Access Compliance Report

Public Rights-of-Way

(Pedestrian Signals)

Intersection ID: N/A	Main Street:	Cross Street: N/A	Location: N/A
ADA ID: E912077A626D	Signal Type: One Push Button-APS	Overall Compliance: No	Severity Score: BTN 1: N/A BTN 2: N/A No BTN: N/A
Codes/Mitigation Info/Possible Solution		Field Measurements/Component Compliance

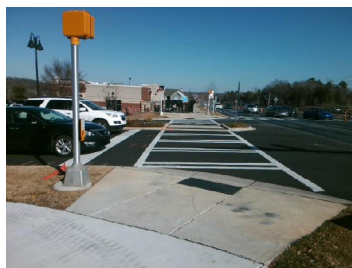
PROW/ADA: TMUTCD 4e.08, R404.3, R404.2, R404.7.2

N/A	B 1 Clear Xing Direction?	Yes	N/A	B 2 Clear Xing Direction?	N/A
	B 1 Crossing Direction	To NE		B 2 Crossing Direction	N/A
No	B 1 DistanceTo XWalk (in)	83.0	N/A	B 2 DistanceTo XWalk (in)	N/A
Yes	B 1 DistanceTo Curb (in)	48.0	N/A	B 2 DistanceTo Curb (in)	N/A
Yes	B 1 Diameter (in)	2.0	N/A	B 2 Diameter (in)	N/A

Possible Solutions: Replace Signal Push Button With APS Button on New Post. Remove & Relocate Sign.
